Comparison Report

1. Pin Header Package Dimension

OLD	NEW
3FM00202520 / 3FM00302520/3FM00402520 3FM00502520 / 3FM00602520/3FM00702520 3FM00802520 / 3FM00902520/3FM01002520 CONN.M (2021-XX,TOP,2.0mm,EVER)	3FM00202550 / 3FM00302550/3FM00402550 3FM00502550 / 3FM00602550/3FM00702550 3FM00802550 / 3FM00902550/3FM01002550 CONN.M (W2011- XX SVA-B,TOP,2.0mm,XINYA)

2. PICTURES

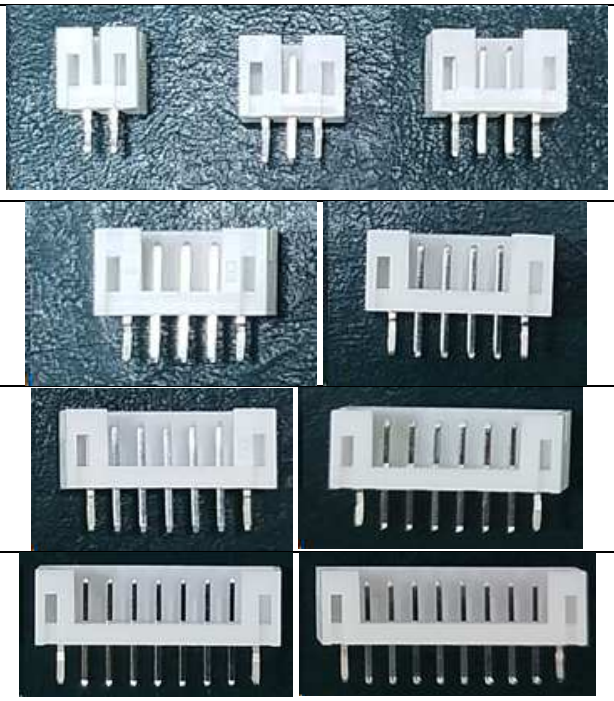
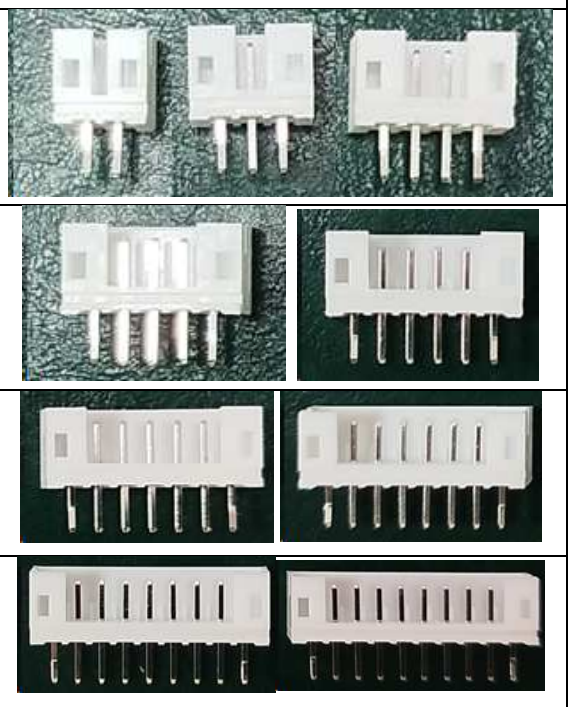
Item	OLD Part	NEW Part
Front View
